Docket No. 50-346
License No. NPF-3
Serial No. 530
August 2, 1979

This is in response to your letter dated July 2, 1979 requesting additional information concerning the determination of core parameters during the rod drop test at Davis-Besse Nuclear Power Station, Unit 1.

Responses to NRC Questions on Davis-Besse Unit 1 Rod Drop Test

Figure A

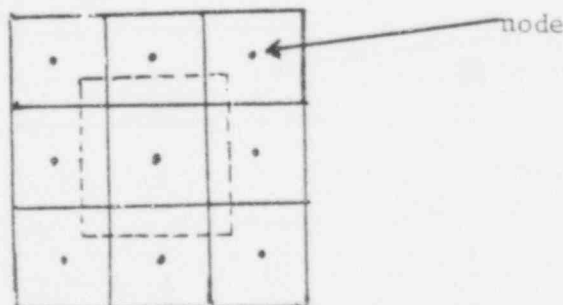
We have studied BAW-10123 Nuclear Application Software Package for 205-fuel assembly plants and assume that the radial local peaking factors are calculated in a similar manner for 177-fuel assembly plants. Describe in detail how radial local peaking factors are calculated for the "dropped rod" situation which is very different from "fuel-cycle design rod positions" as discussed in Section 3.8.2. If a multiplicative correction factor was used, please provide details as to how it was calculated. Also describe how you account for the uncertainties in the radial local peaking factor.

The 177 FA Mark-B plant OLC calculates local peaks much differently than the methods described in BAW-10123. The basic method of the OLC calculations is as follows:

1. Determine the hottest bundle.
2. Set up a matrix of this bundle and the surrounding eight bundles (see Figure A).
3. The center location of each bundle will have a node value of its respective radial peak.
4. Each node is weighted to give most importance to the center bundle.
5. A surface fit is applied to the 9 nodes.
6. Any point on the surface fit inside the dashed lines on figure 1 that is greater than the hot bundle peak is taken as the radial local peak of the hot bundle.
7. If the local peak is less than 1.01 then the default value of 1.01 will be used.

Figure B

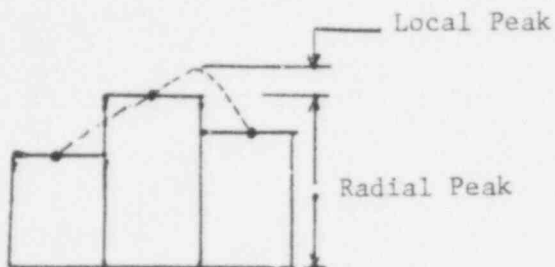
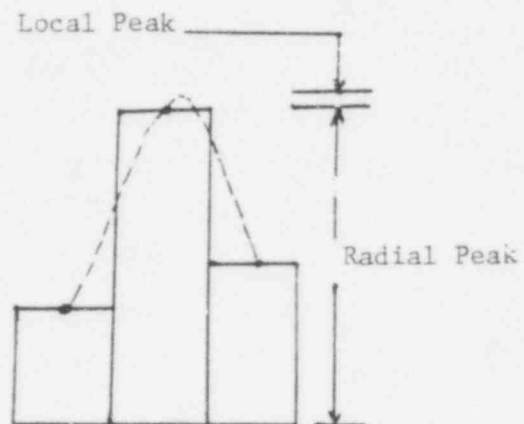
Are the values of radial local peaking factor conservative? If this is the case, justify this conclusion. If not, show how this is taken into account.

Figure B shows a simplistic one-dimensional typical normal operation local peak calculation and a dropped rod local peak calculation. Based on this model, the local peaking factor calculation is usually nonconservative for dropped rod conditions. However, the total uncertainty is such that the final MLHR is a conservative value (refer to the discussion Section I).

FIGURE-4

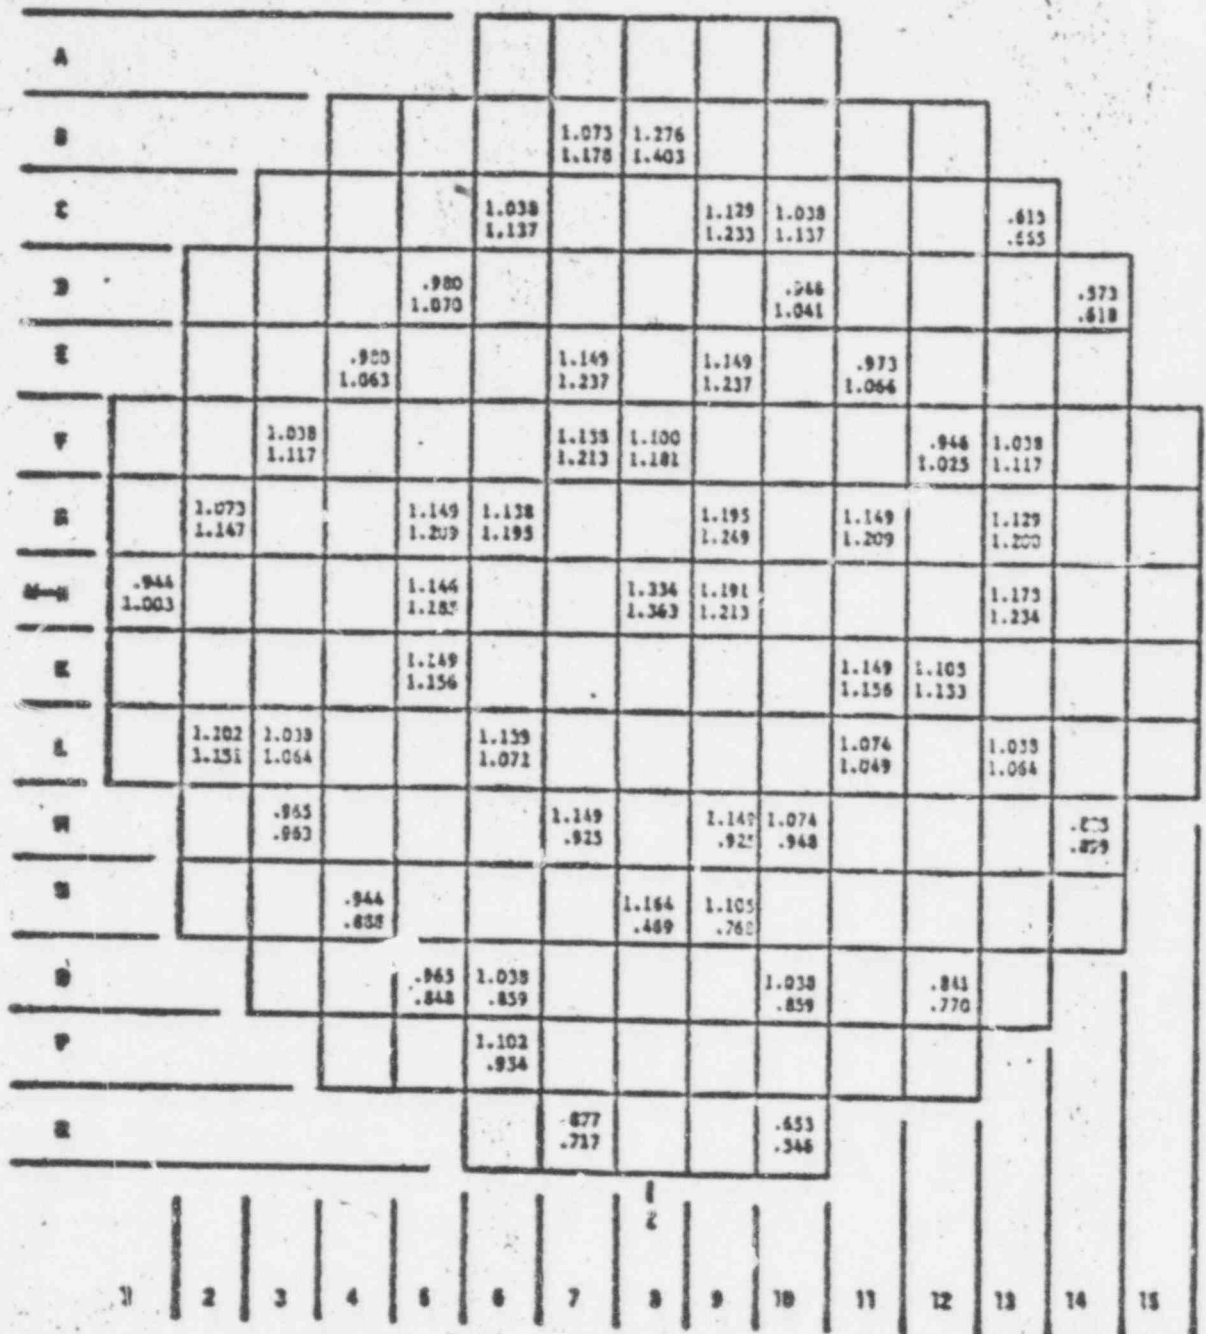
Provide comparisons of calculated and measured radial peaking factors for the "dropped rod" tests at both the 50% and 0% withdrawn positions. It is preferable that these be submitted in the form of core maps.

Core maps are provided giving the requested information for the Rod Drop test of 11/27/77. Both measured and predicted (FLAME 3) radial peaking factors are shown for the appropriate incore detector locations. The predicted and measured peak segment powers are noted in the lower left corner of the page. Figure 1 shows a comparison at equilibrium conditions (42% FP) at 8:30 a.m. Figure 2 shows the core at 11:06 a.m. with the control rod in core location N-8 fully inserted. Figure 3 presents a similar comparison for the control rod at N-8 50% withdrawn which occurred at 12:18 p.m.

In addition to this data, cases were also run at 100% full power with the same control rod positions as those of the test (initial conditions and N-8 fully inserted). These calculations were done to contrast the resulting power peaks with those at the 40% FP level. Figure 4 shows the predicted radial powers for both of these cases. Predicted segment peaks are also shown in the lower left corner, and the nodal (6.0" axial length) peaks are shown in the lower right corner. The value for the peak node after the rod drop, if conservatively converted to Kw/ft as shown in Table 1 below, indicated a maximum linear heat rate (MLHR) of 17.5 Kw/ft, well below the fuel melt limit. This value is also well below both the hand calculation and computer calculation extrapolations of the 11/27/77 test results to 100% FP. Thus it is concluded that extrapolation of measured dropped rod peaks from 40% FP to 100% FP is extremely conservative due to feedback effects at the higher power level. For method of extrapolation, refer to the answer to Question 4.

Figure 5

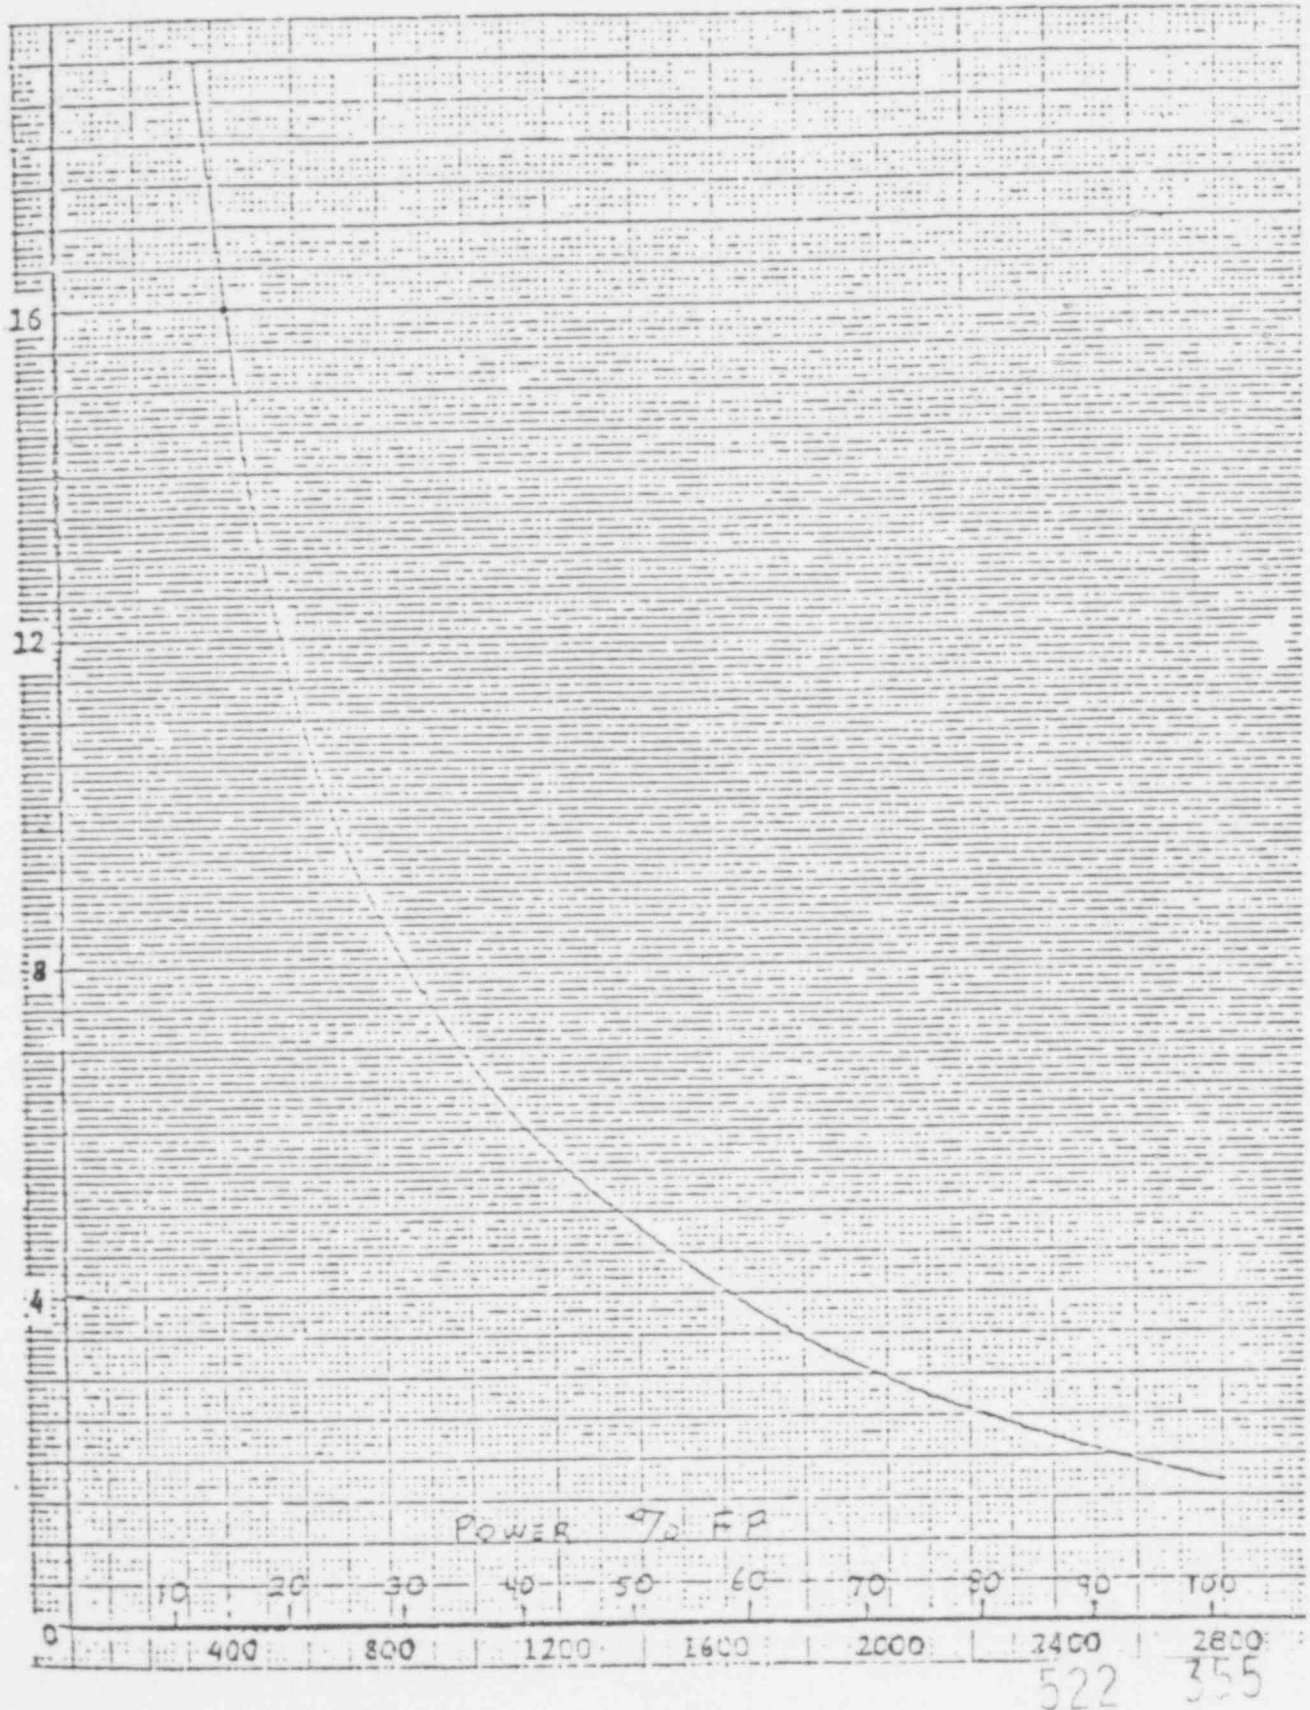
How was the data measured at 40% power extrapolated to 100% power?

1. To extrapolate the MLHR to 100% power, the measured values were multiplied by 100/(power level at which the test was conducted i.e. 40% power).
2. To extrapolate the minimum DNBR, the measured DNBR is plotted on Figure 5 (attached) and a curve parallel to the curve on Figure 5 is extended from the plotted point to the 100% power level. The resulting point gives the minimum DNBR extrapolated to 100% FP.
